GREENWOOD APARTMENTS

DESIGN REVIEW BOARD MEETING - 12/5/16

9039 GREENWOOD AVE. N. SEATTLE, WA 98103 (DPD #3023181)

^ AXONOMETRIC - CORNER OF N 92nd ST & GREENWOOD AVE NORTH

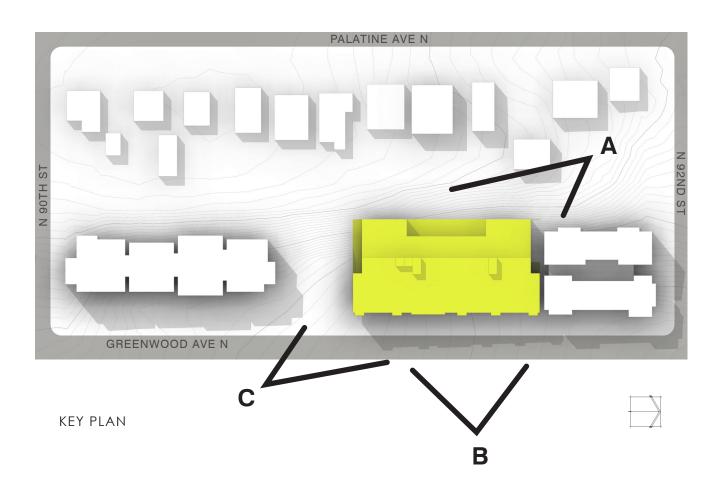
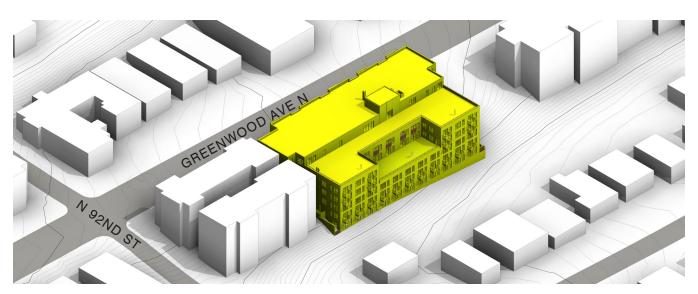
A. Members decided, through setbacks, terracing, and modulation, it responded sensitively to the residences across the alley. (DC2A1&2)

B. The approved massing design also showed potential to provide interest along the street through a well-defined entrance and vertically articulated bays. (DC2-B1)

C. The Board liked the possibilities offered by balconies located inside extruded bays. (DC2-C1)

1. Massing:

The building steps down towards the alley side in order to reduce the verticality of the west facade.

The design intent at ground level draws pedestrian level interest and carries vertically within each bay.

The balconies and accompanying railings add variety to each bay of the street side facade (See elevations for more detail).

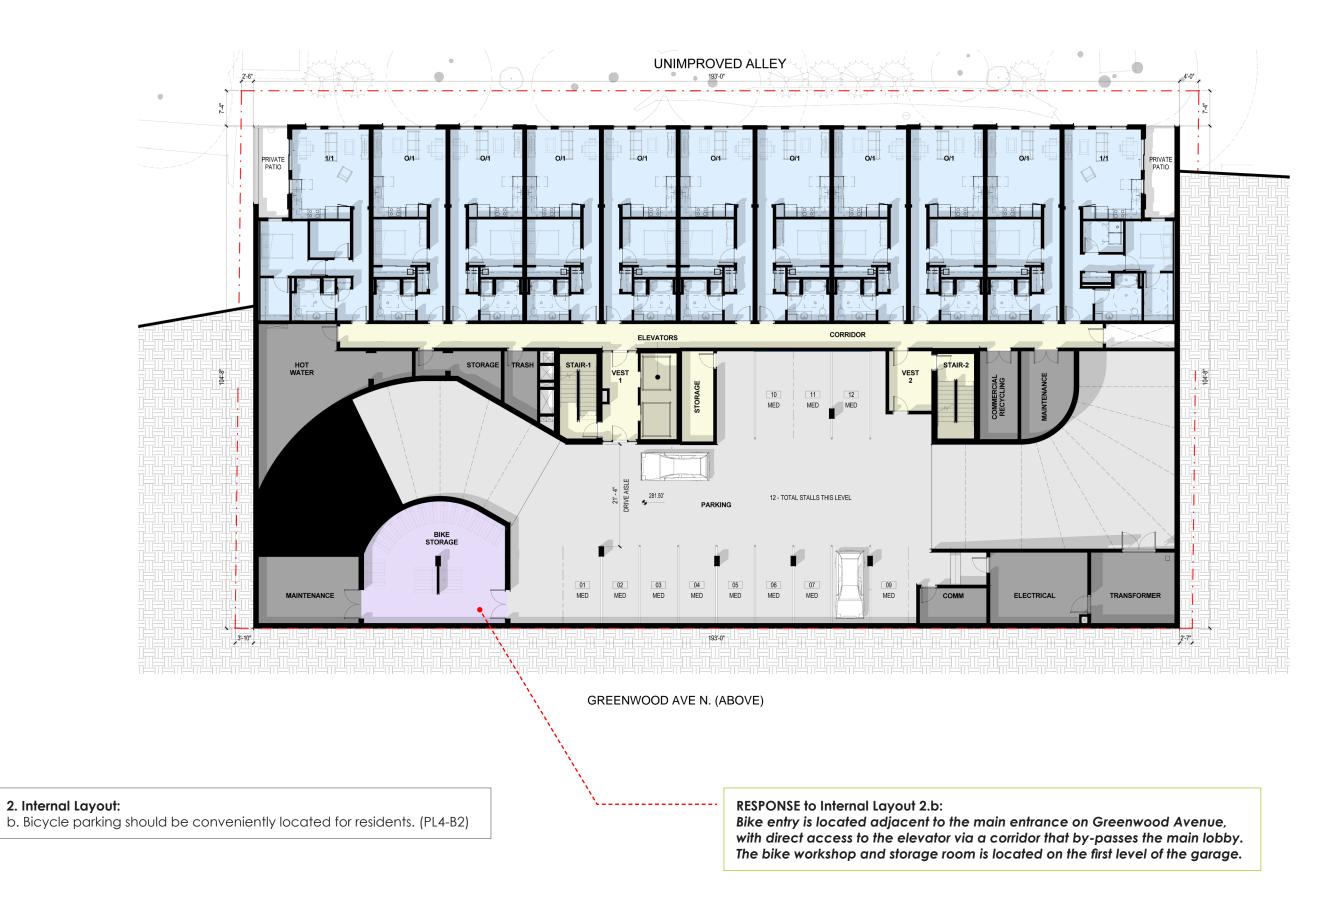
a. Live/work units entries should be distinct and properly relate to the sidewalk through landscaping and material changes. (PL3-A3 &PL3-B3) **RESPONSE to Exterior Elements 4.a:**

a. As the design evolves, consideration of access to light and air for units facing north, south, and the alley should be taken into account. (CS1-B2)

b. Any seating areas or active uses should be setback from the edge of the roof. (CS2D3)

a. The Board favored the U-Shaped Terrace because it removes mass from the structure as it addresses and responds to the smaller residential uses to the west. (CS2-D1)

Ample setbacks at the ground level offer a sense of place and defensible space for the Live/Work units along the street. Private entry points within the landscape offer a distict identity for each unit.

RESPONSE to Context 3.b: On the lower terrace, a large central planter offer privacy for both the single family and the apartments.

EAST ELEVATION

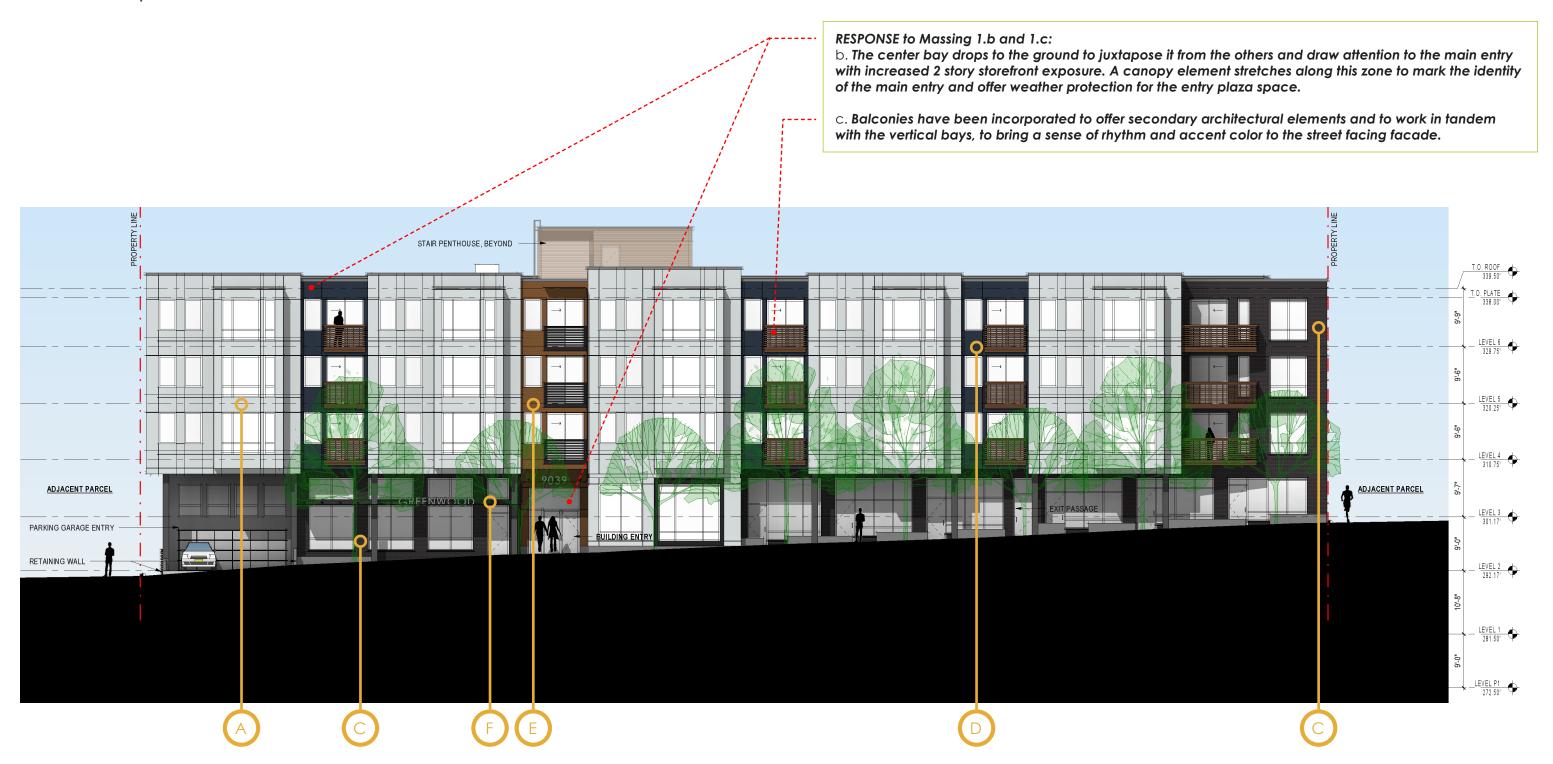
1. Massing:

b. Option C also showed potential to provide interest along the street through a welldefined entrance and vertically articulated bays. (DC2-B1)

c. The Board liked the possibilities offered by balconies located inside extruded bays. (DC2-C1)

NORTH ELEVATION

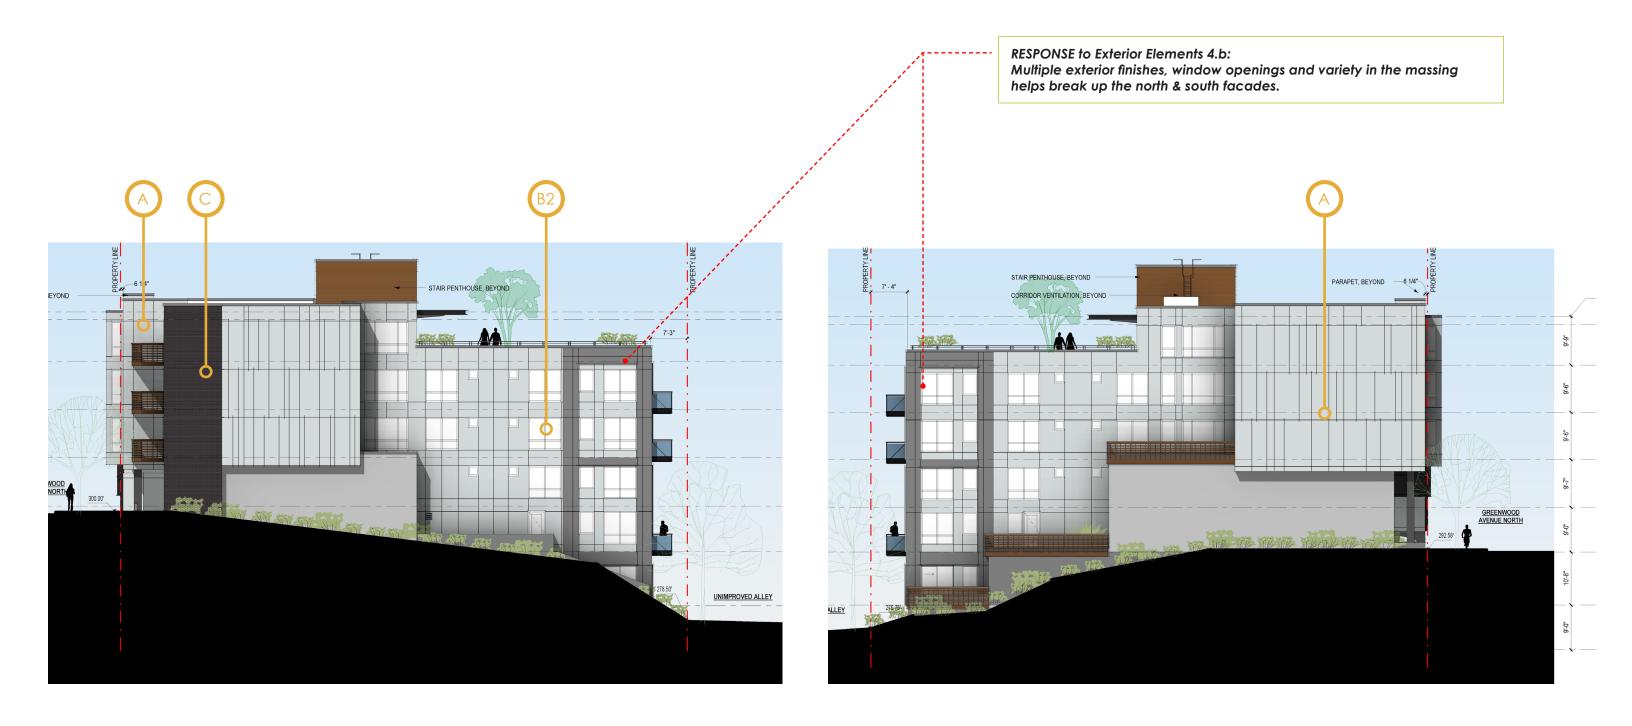
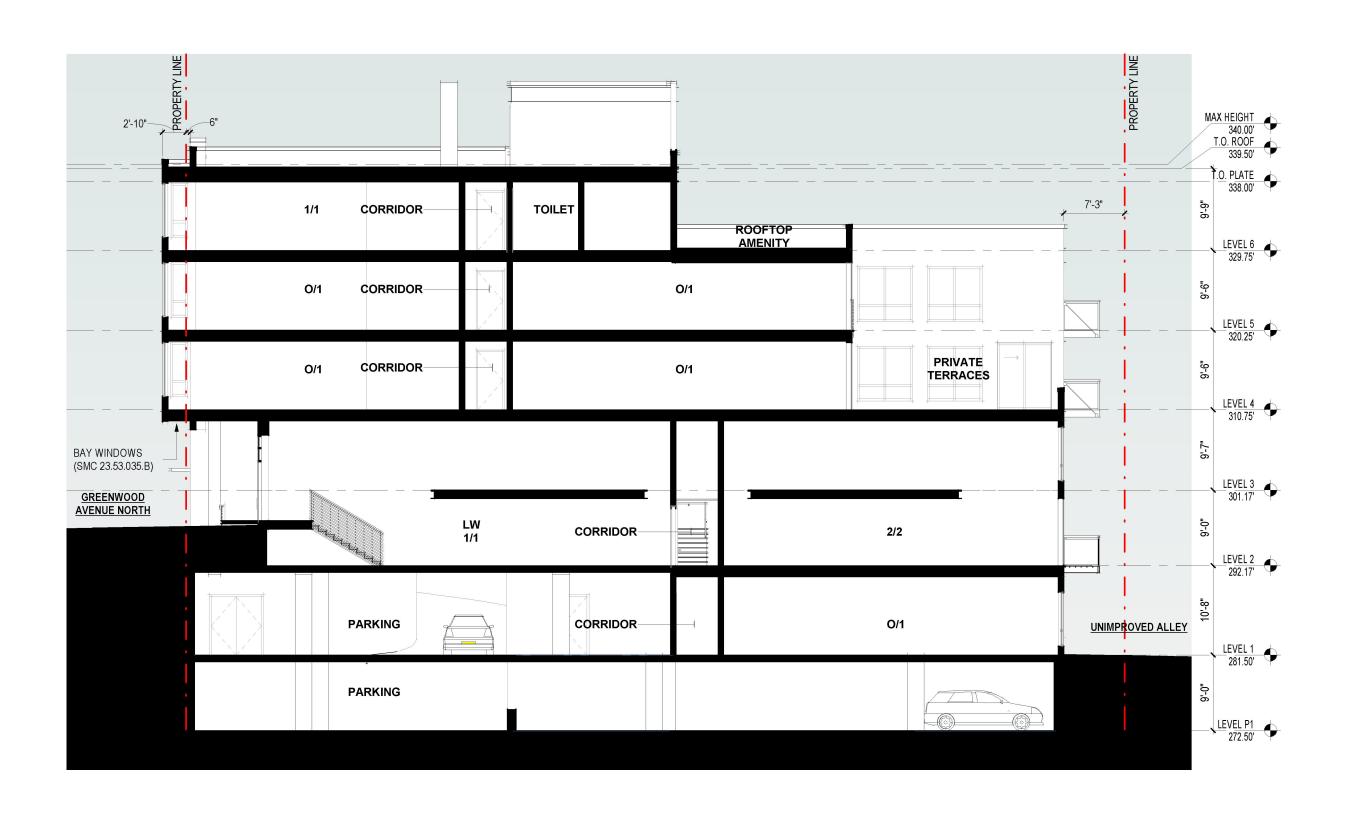
4. Exterior Elements:

b. Since the property to the south is unlikely to redevelop in the near future, the design should avoid large sections of blank façade as it will be highly visible from Greenwood. (GF-DC1-I & DC2-B2)

CANOPY - ENLARGED ELEVATION CANOPY - ISOMETRIC VIEW

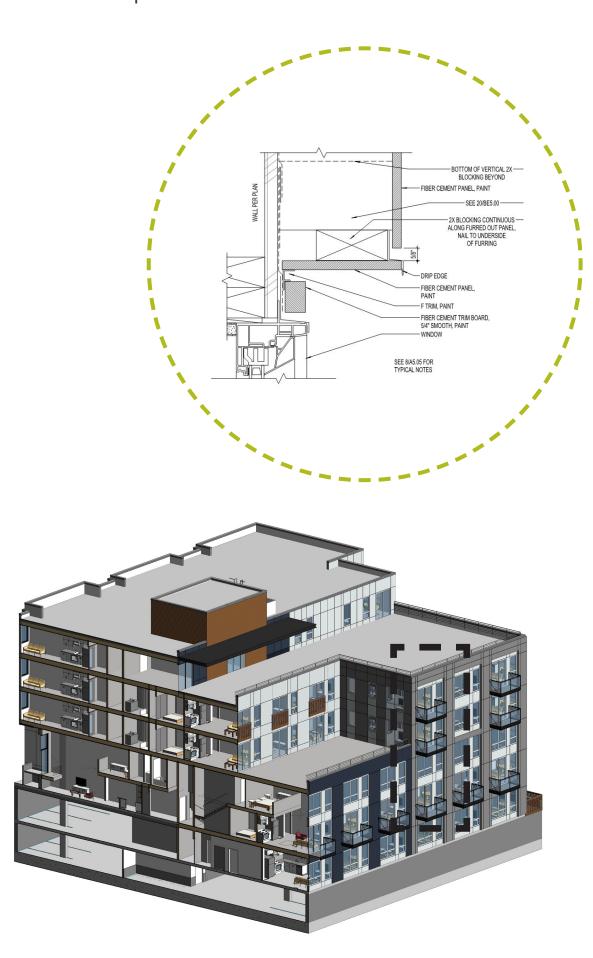
MUP COMMENT #3 - Entry:

The Board wanted a prominent residential entry. Consider merging the entry with the with the recessed bay on floors 2-5 or changing the canopy height to make it stand out more.

NORTH ELEVATION - NEIGHBORING BUILDING WINDOW OVERLAY

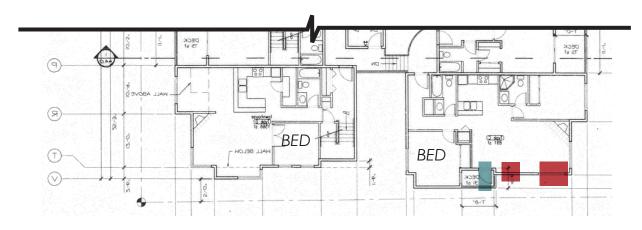
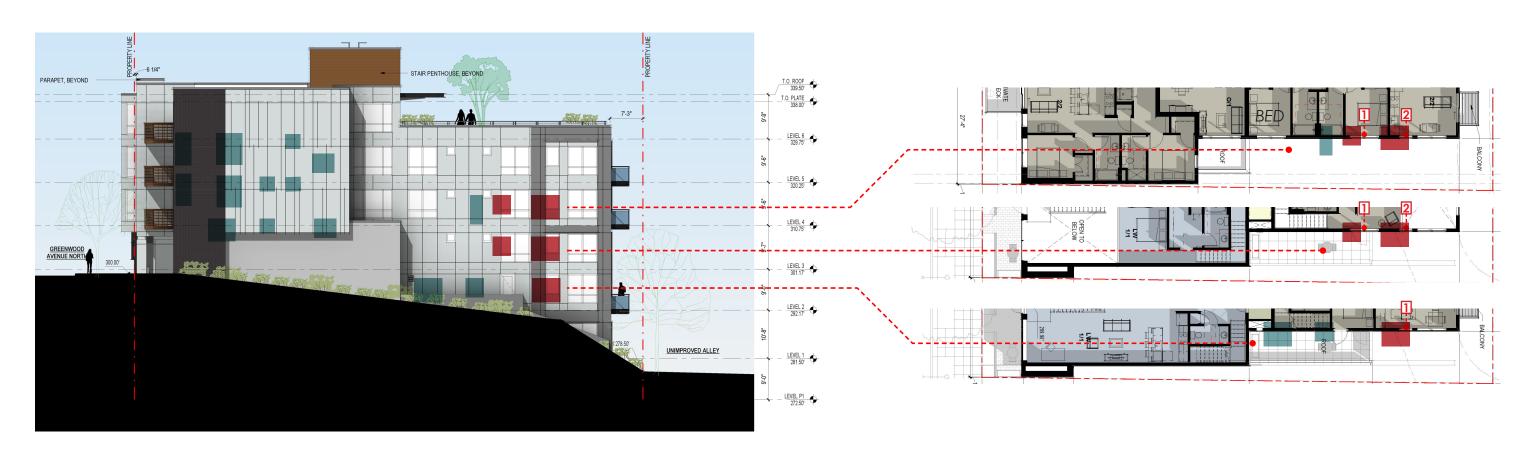
3. Context:

d. The recommendation packet should include window studies to the north, south, and west to adequately inform the Board of possible privacy impacts. (CS2-D5)

RESPONSE to Context 3.d:

Most windows of the existing multi-family building to the north do not have any privacy concerns with the proposal (Refer to the elevation overlay). See below for design suggestions for the windows that do create a privacy concern.

PROPOSED - SITE SECTION

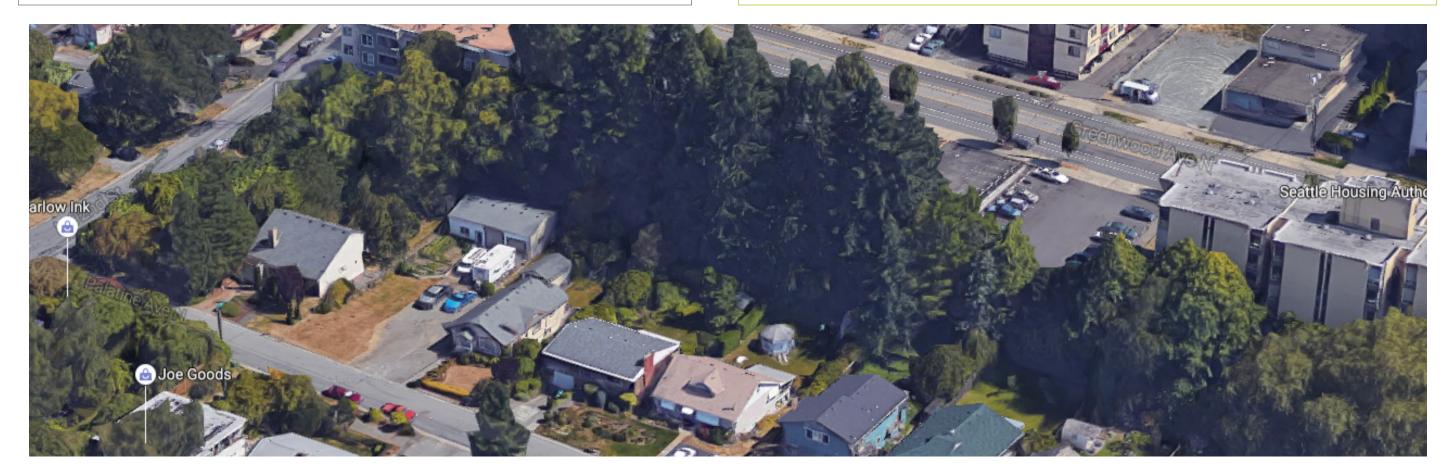
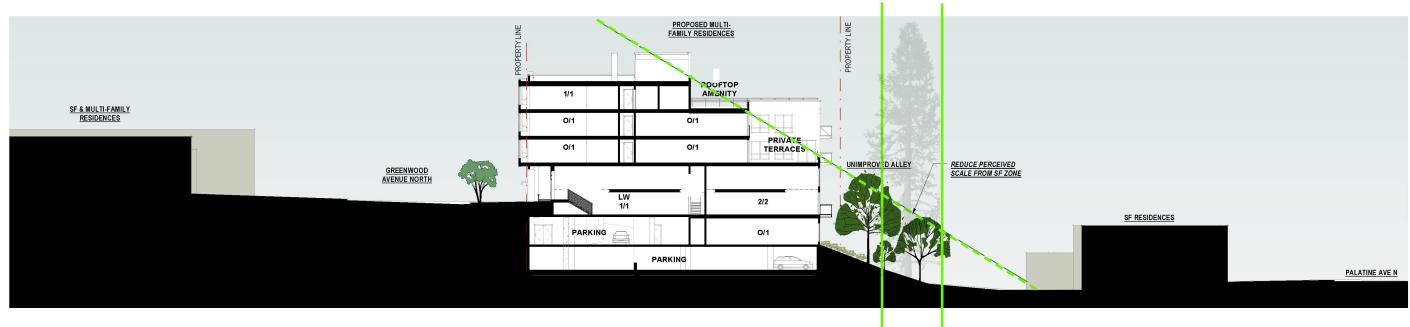
3. Context:

c. The trees in the unimproved alley form a natural visual buffer. If alley improvements are required, a landscape buffer should be included along the western property line. (CS1-D1&2)

RESPONSE to Context 3.c:

The existing trees to be removed for the project will be replaced with a landscape buffer (shown below). Coupled with the stepped massing this will reduce any visual impact to the neighboring homes.
